Saint Ignatius' College - s4.55 Modification to SSD 7140

DECEMBER 2019

Proposed Modifications

REVISED FUTURE STAGES | UPGRADE RECREATION COURTS PRECINCT

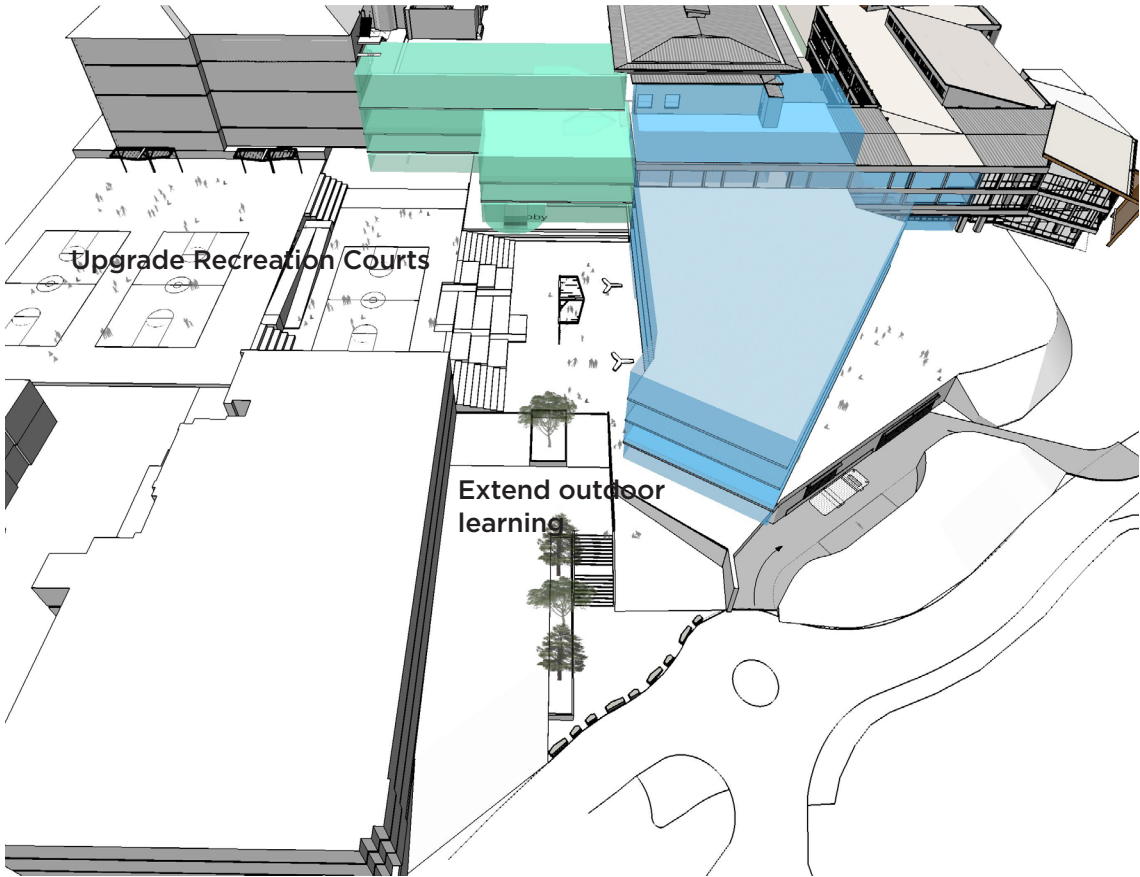
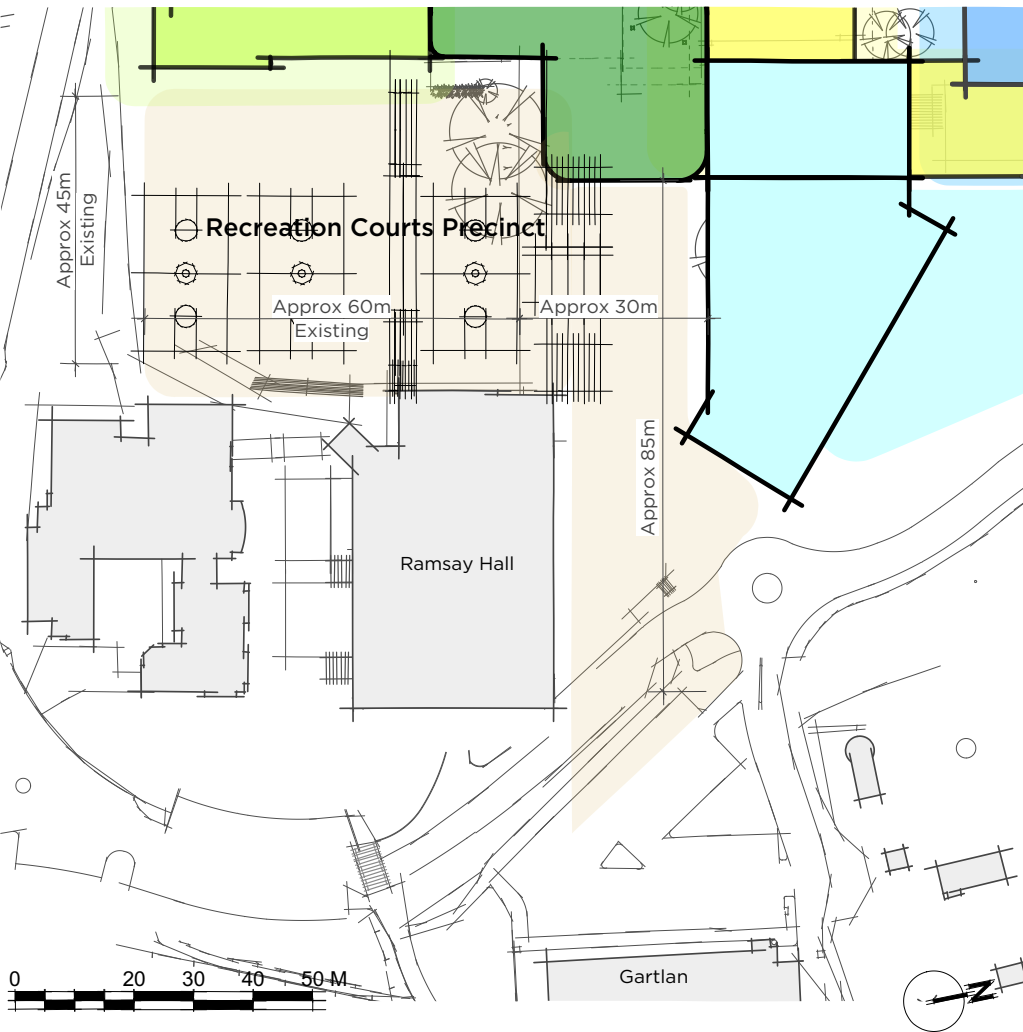
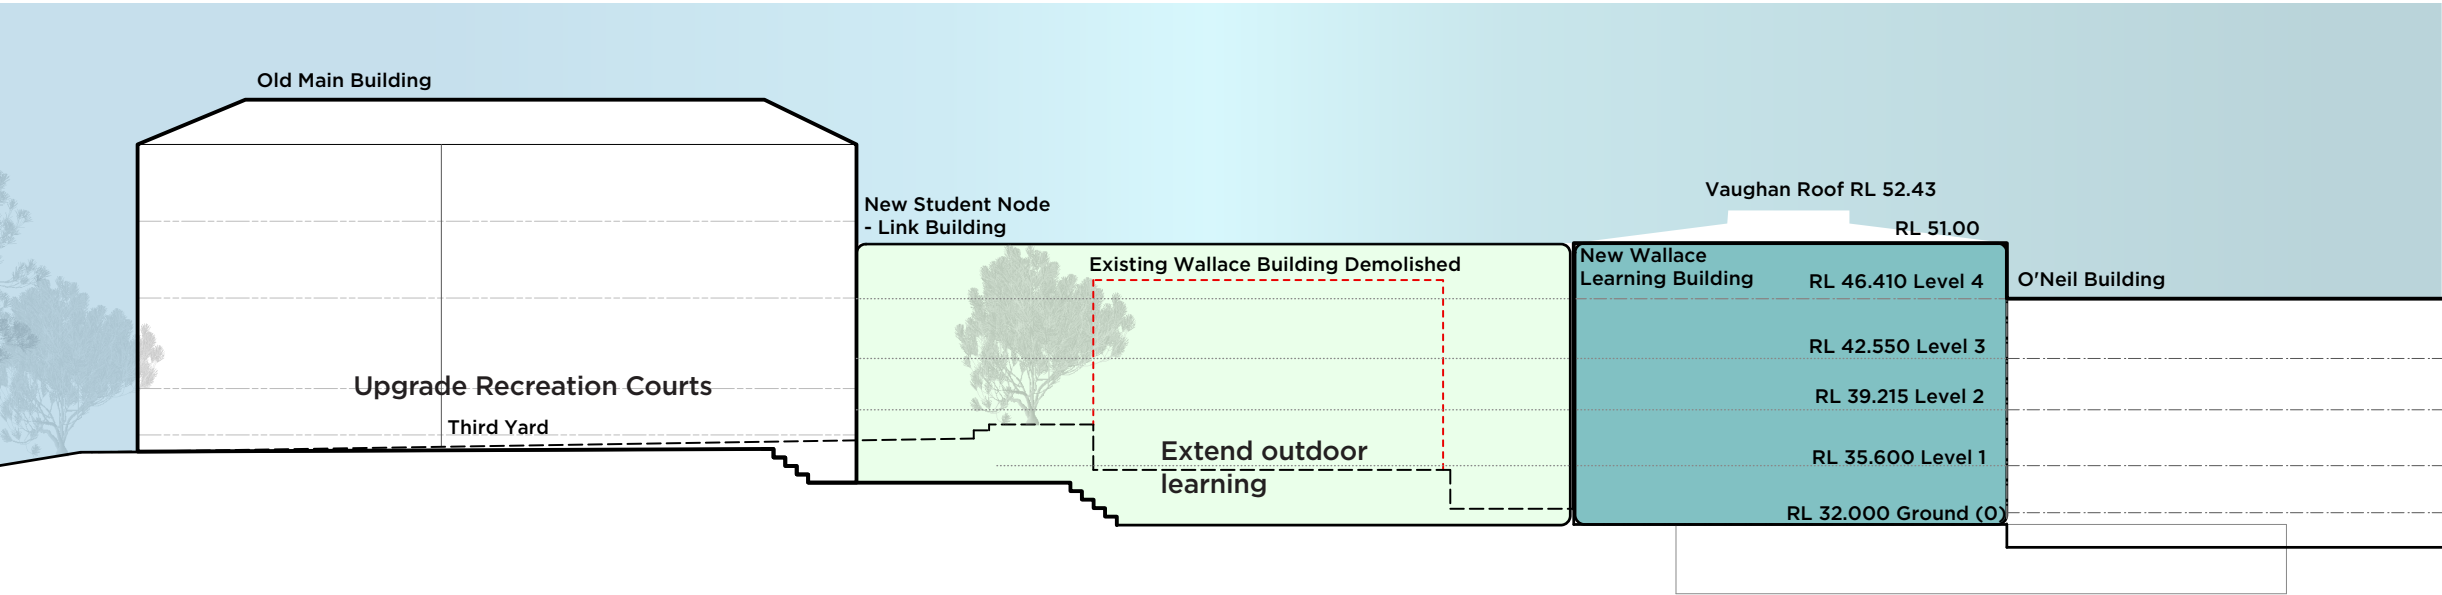
- Additional GFA = Nil
- Number of Levels = 1

Remove approved podium design and replace with reduced proposal that focus on reinvention of existing outdoor and area left from the removal of Wallace to create purposeful and quality outdoor & recreational space. Solution is for creation of outdoor areas as extension of learning space, gathering opportunities and retaining the need for recreation areas for basketball and handball. No existing parking will be lost in this solution.
